APPENDIX B

REVISED SPEED CUSHIONS

Revised Speed Cushions
Dalkeith Grove

Drawing no
LBH/TM/CF/T/PR/0056/01

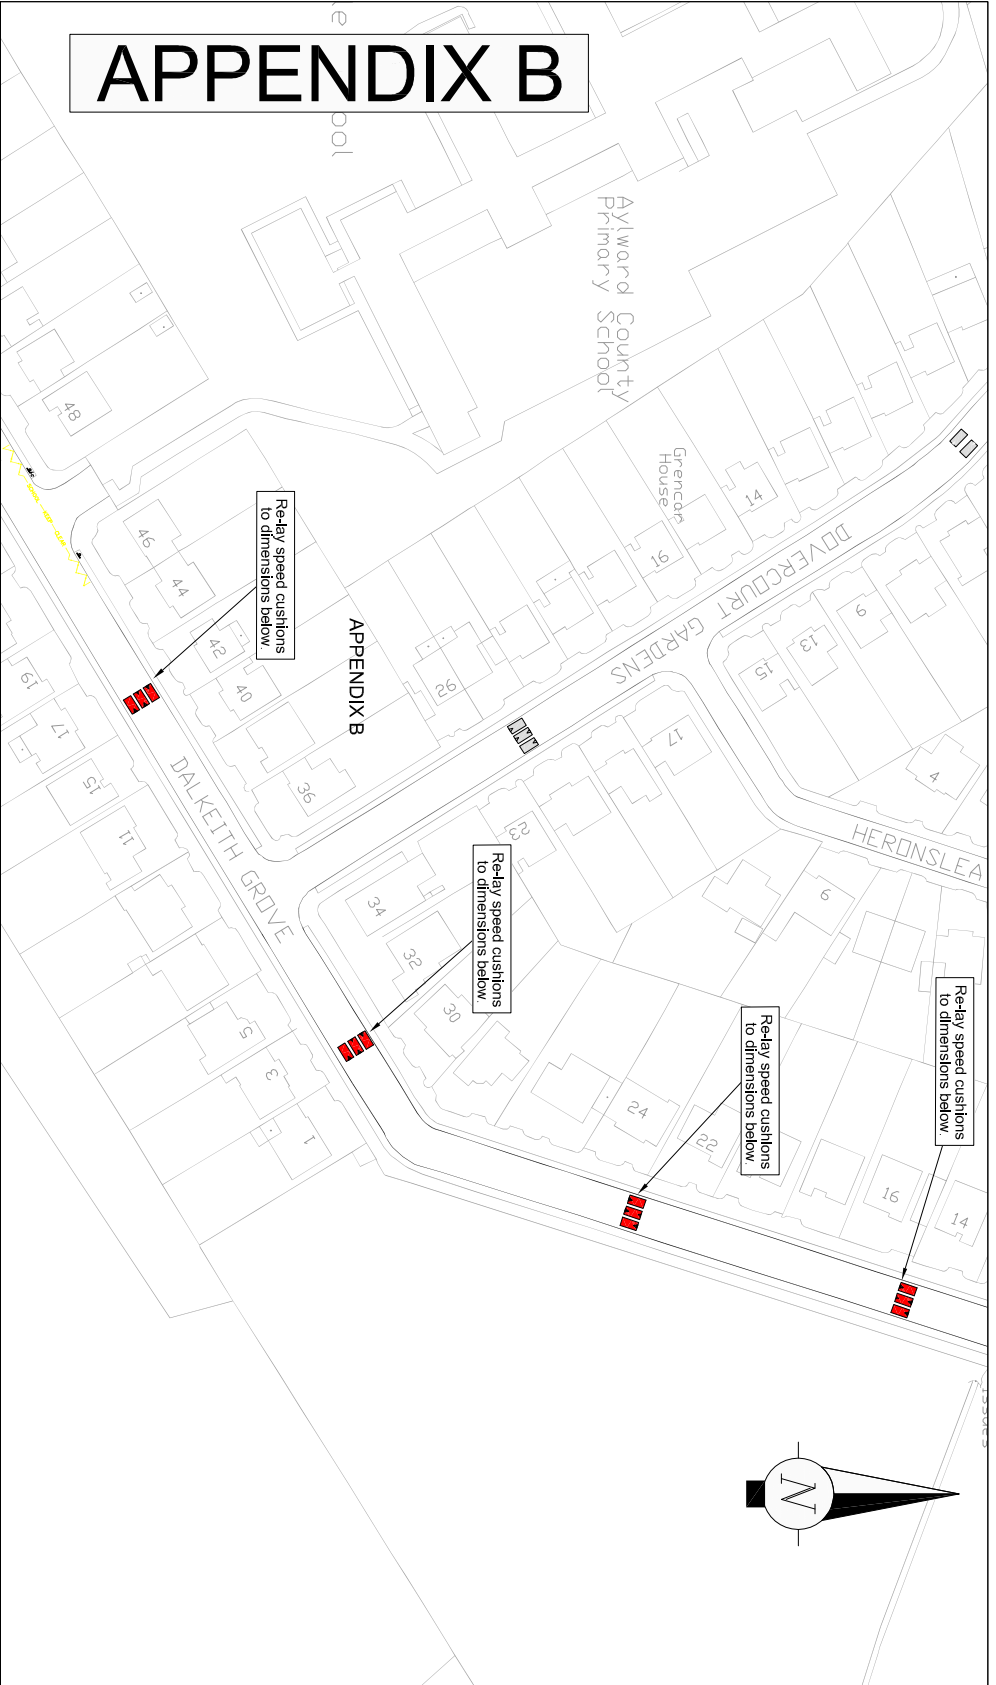
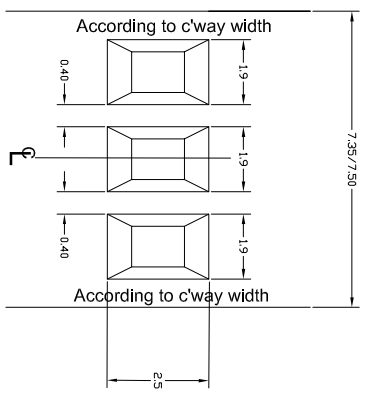
-  Existing speed cushions to be altered
-  Existing speed cushions to be retained unaltered

- Cushions to be 75mm in height.
- Slope in on/off direction should be 1:8.
- Slope of side gradients should be 1:4.
